Docket Item # 3
BAR CASE #2010-0152

BAR Meeting
July 7, 2010

ISSUE: Alterations
APPLICANT: Glen and June Zauber
LOCATION: 413 Green Street
ZONE: RM/Residential

The applicant is requesting approval of a Certificate of Appropriateness for replacement windows at 413 Green Street.

Figure 1: Photograph of Existing Windows – Front Elevation/Green Street

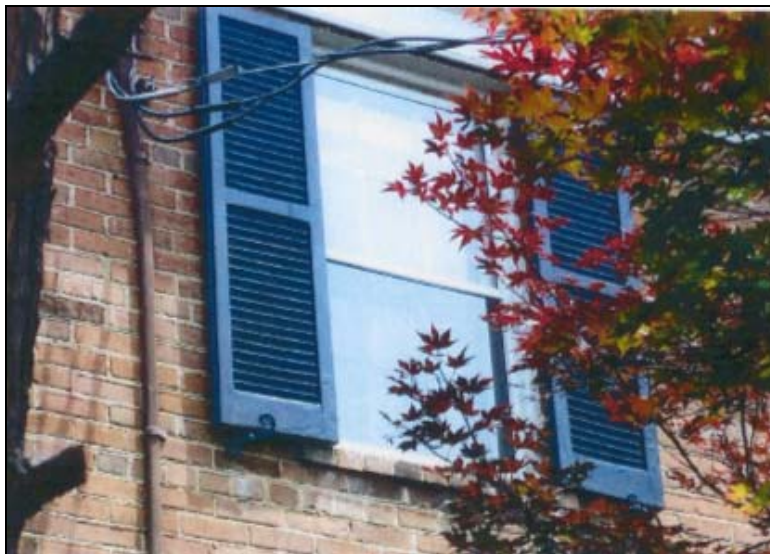
The applicant is requesting approval to replace a total of 13 windows; four on the front of the home facing Green Street, five on the side elevation and four on the rear elevation. The existing windows are single-glazed, double-hung, 6/6 wood windows with exterior storms. The applicant is requesting approval of Marvin Ultimate Wood Double Hung Magnum double-glazed windows with 7/8" muntins. The proposed windows will be simulated divided light with an interior spacer and an identical light pattern to the window they are replacing.

423 Green Street was built in **1942**. This two-story masonry, Colonial Revival townhouse is a side entry townhouse with a side gable roof facing the street and 6/6 wood, single glazed, true-divided light windows flanked with operable two-paneled louvered shutters. The front door is a raised panel door detailed with a simple surround.

Therefore, given the age of the townhouse and the fact that the existing 6/6 light pattern and putty glazed muntin profile and size will be retained, Staff does not object to the installation of painted wood double-insulated windows, with simulated divided light, and dark colored interior spacer bars. Staff finds the proposed replacement windows appropriate and reminds the applicant that as of June 1, 2010, window replacement requires a building permit within the historic districts.

Figure 5: Specifications sheet of proposed replacement windows

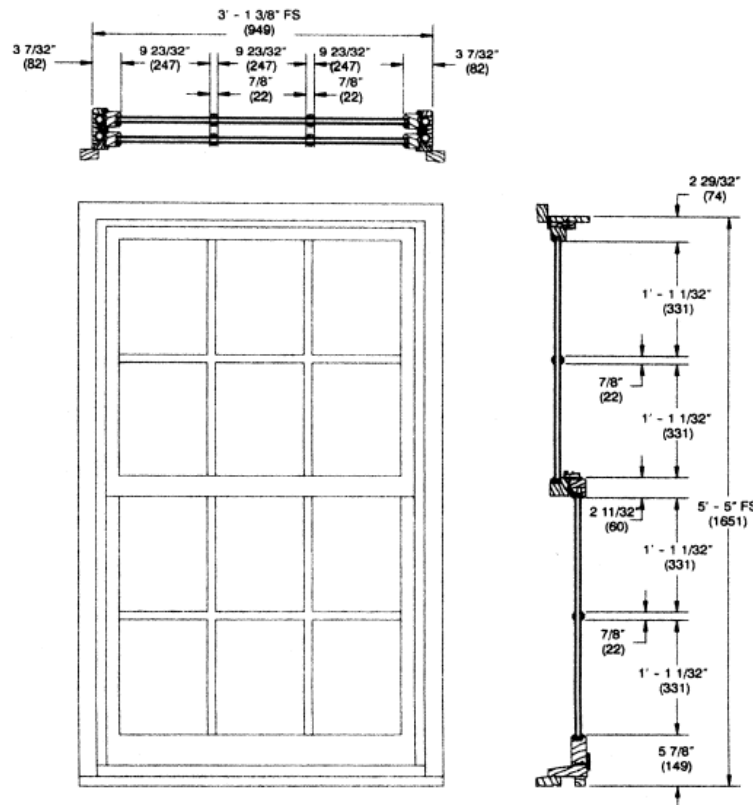
In this particular case, Staff believes that double glazed windows, which were invented in the 1930s and commonly available in the 1950s, when this townhouse was constructed in 1942, are appropriate replacement windows and significantly more attractive than the existing single glazed windows covered by aluminum storm panels. Staff further believes that the appearance of modern simulated divided light windows is indistinguishable from true divided light sash and allows the profile of the muntins to be thinner and more historically accurate.
